Index 102-613

Multilane, Work Within the Travel Way – Median or Outside Lane

COMMENTS AND RESPONSES

SINGLE LANE CLOSURE

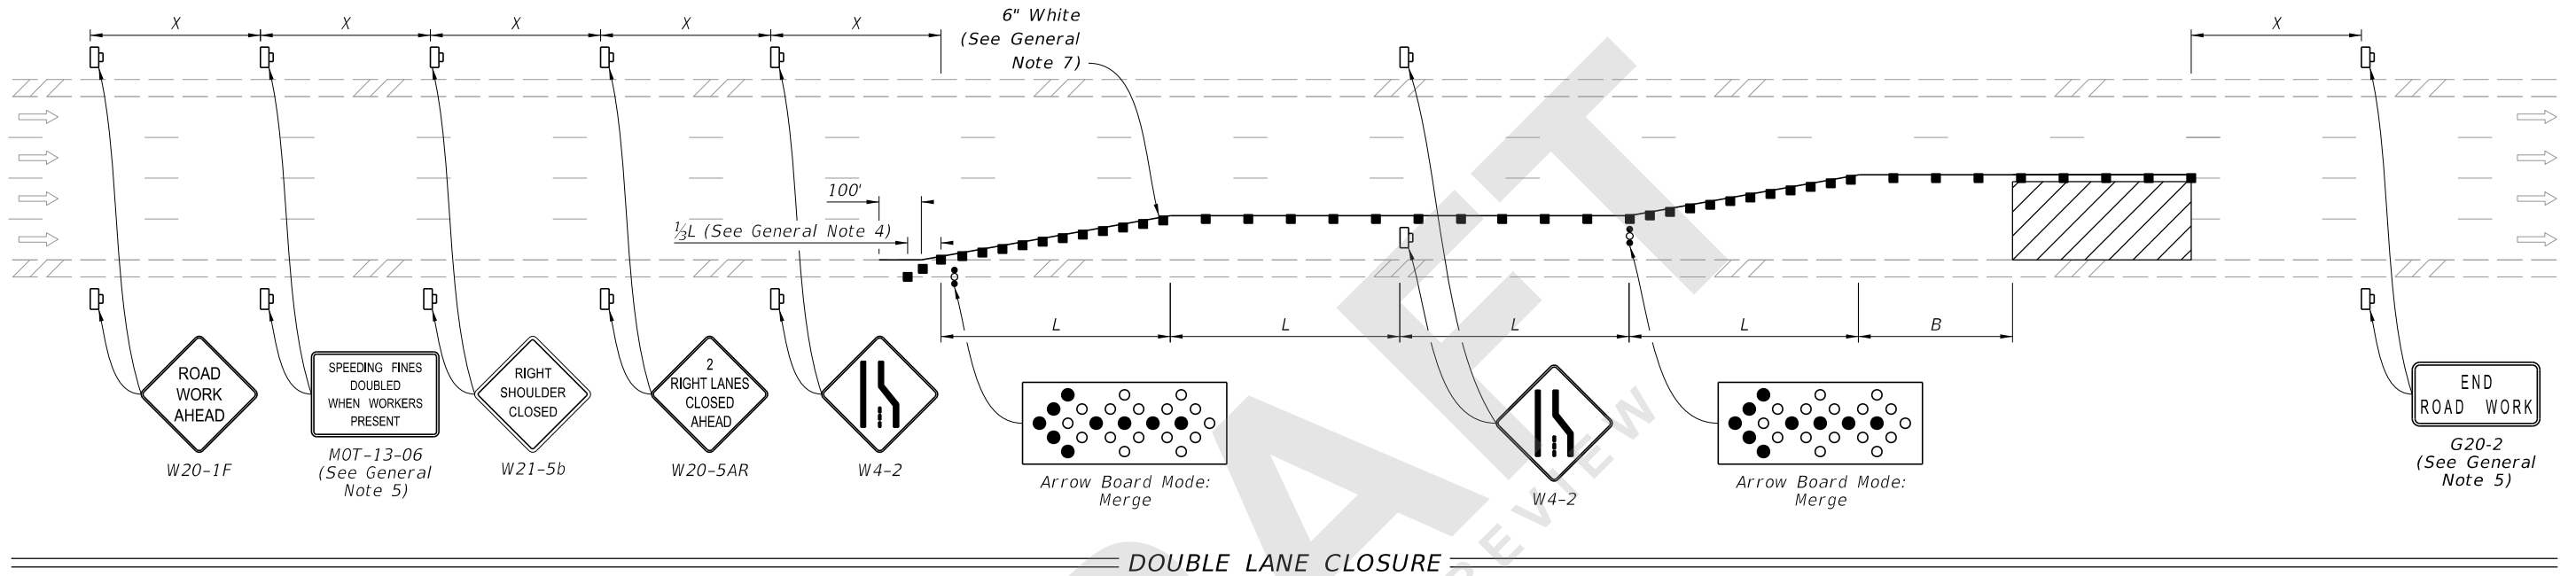
COMMENT: The duration provision has been deleted-this has been used by maintenance.

COMMENT: Sheet 1, General Note 3: Reason to omit shoulder closure signage only on limited access facilities? Seems counter-intuitive for long-term conditions (> 24 hrs, per Note 5) and does not agree with MUTCD Typical Application TA-6. If the intent for the Standard Plans is to better align with MUTCD, considerations for note to be modified to retain signage.

RESPONSE: *As with other Indexes in the 102 Series, the “Duration” notes have been revised and included in the General Notes of the new Index (See Notes #5 & #7). While it is recognized that short-duration work may not warrant an extensive advanced warning area, signage, and devices of a long-term closure; the Department no longer supports the omitting channelizing devices for a lane-closure. However, after additional consideration an allowance for omitting the “Arrow Board” and “Buffer” will be included for work operations of 60 minutes or less on roadways with a speed limit of 45 MPH or less.*

Change Made: *Note #5 revised to allow for omitting arrow board and buffer space for work operations of 60 minutes or less on roadways with a speed limit of 45 MPH or less.*

RESPONSE: *Index 102-613 includes adaptations of MUTCD TA-33 and TA-37. ‘Shoulder Closed’ signs are not included in these typically applications because once a lane is closed there should be no expectation that the shoulder is open.*

Commentary: *In recent standards, the Department has not required the use of “Shoulder Closed” signs and for the most part they are “optional” per the MUTCD (with the exception of freeway shoulder closures and for these Index 102-602 would apply). Where used in the MUTCD they are used to communicate to drivers that the shoulder is not available for disabled vehicles. However, in an effort to better communicate information to non-motorist that use the shoulder (e.g., bicyclist), the shoulder closed signs have been more broadly applied in proposed new Indexes. Additionally, because Limited Access roadway shoulders are not considered a bicycle facility, the allowance to omit the sign was provided.*

LANE CLOSURE WITH LANE SHIFT

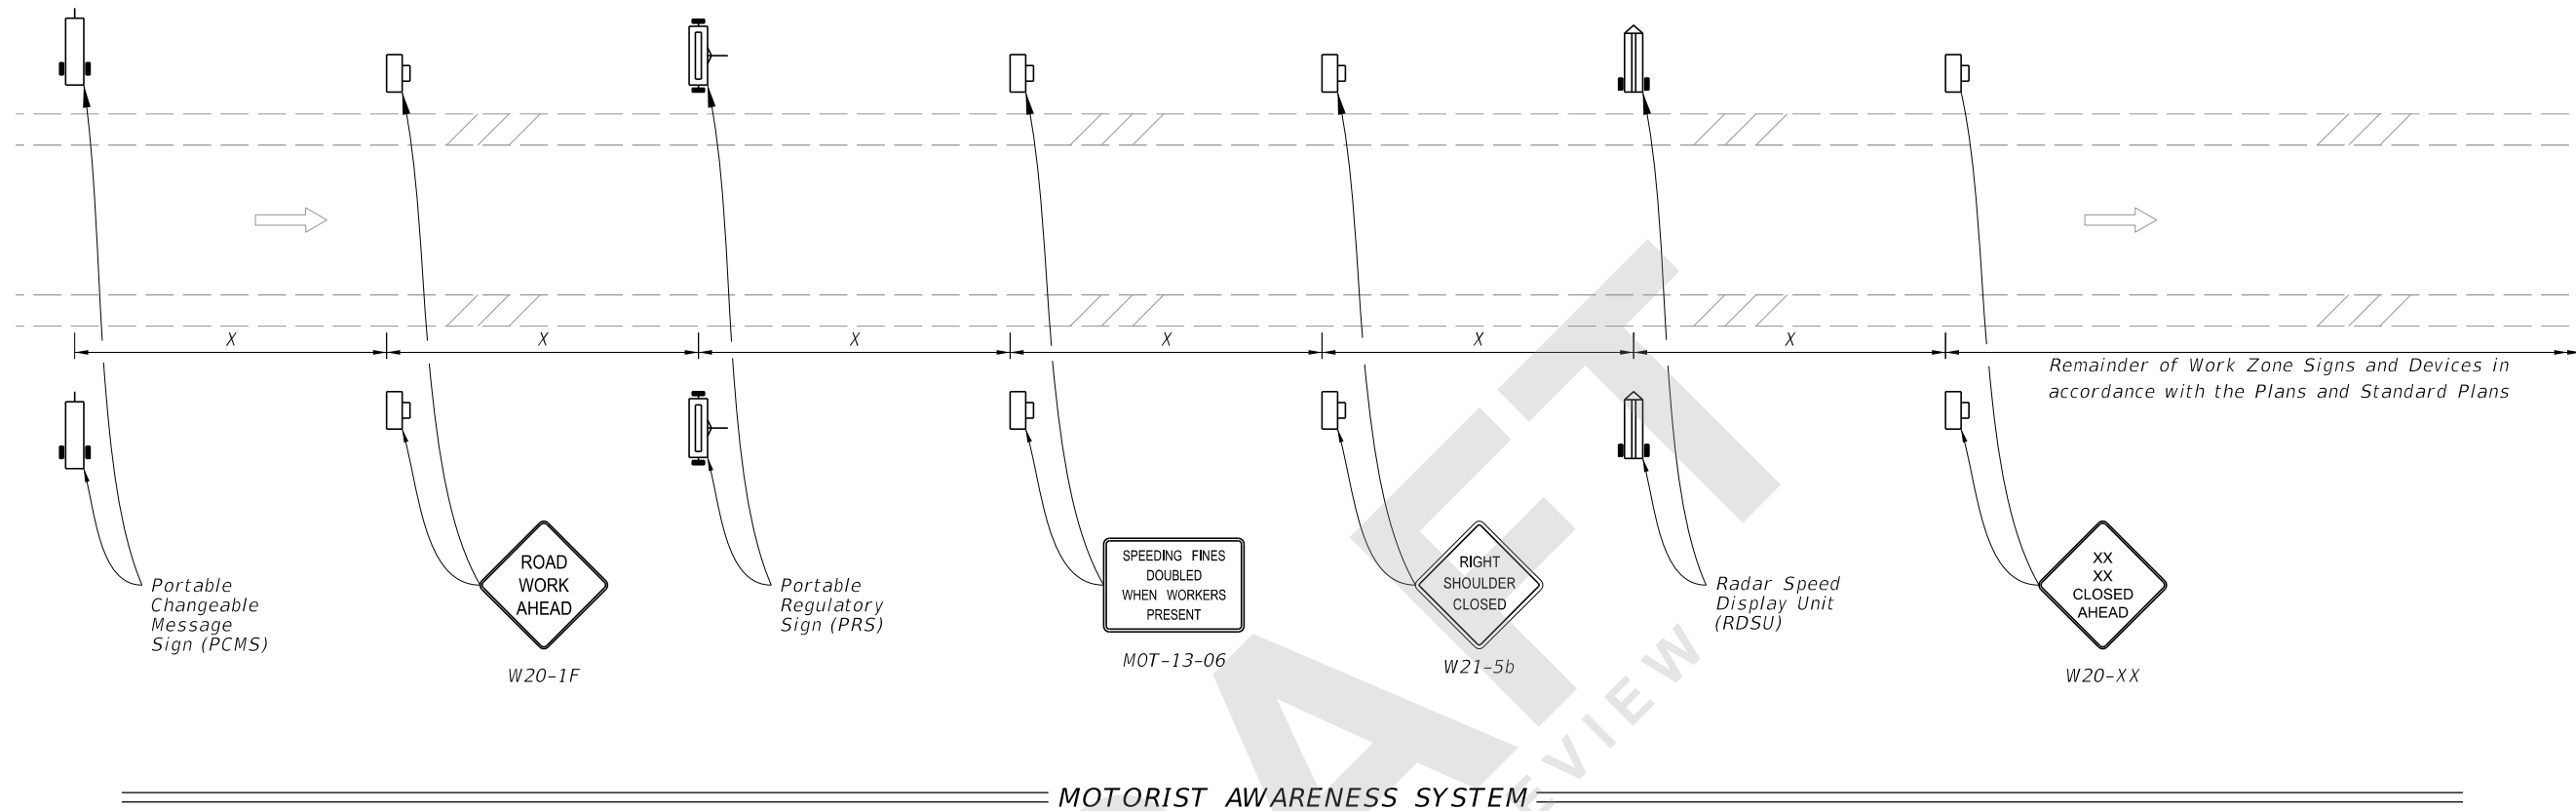
1. 102-613 (4/5): Why is the taper used to bring back traffic to the original alignment only 1/2L? This is a shift in the alignment and the normal taper should be used.

2. 102-63 (4/5): Why is there no channelizing devices on the right side edge at the end taper (Right end)?

3. 102-613 (4/5): At the center of the shift, a distance "L" is used on the left side edge, but a length "B" is used on the right side edge. This is a taper in both sides and the length should be the same. If you use different lengths, we end with an unbalanced road and/or wider lanes. Example, at 40 MPH, L would be 640' and B will be 305'. The lanes will not be parallel.

COMMENT: Index 102-613. Sheet 4/5 – Include a note or label that Applies to full width shoulders..... - Roadways with sub-standard shoulder widths will require an additional thru lane closure upstream to compensate or if right of way exist temporary shoulder widening may be required for diversion.

RESPONSE: *In accordance with the MUTCD, Merging Tapers use the full “L” value, shifting tapers use “1/2 L”, and Shoulder Tapers “1/3 L”.*

MUTCD does not use channelizing devices on the outside of lane shifts. Within a diversion temporary striping delineates lane location/width.

RESPONSE: *Agreed. The dimension "B" should not be included, as length "L" shown on the left-side edge would control the overall length of the taper.*

Change Made: *Deleted dimension "B" from right-side shifting taper.*

RESPONSE: *Along with the requirements of Specification 102, the "Lane Width" requirements included on Index 102-600 would control the availability of the shoulder for use a lane during TTC operations, as well as control the usage of "Lane Closure With Lane Shift" detail. Additional notes may be confused, or conflict, with other requirements.*
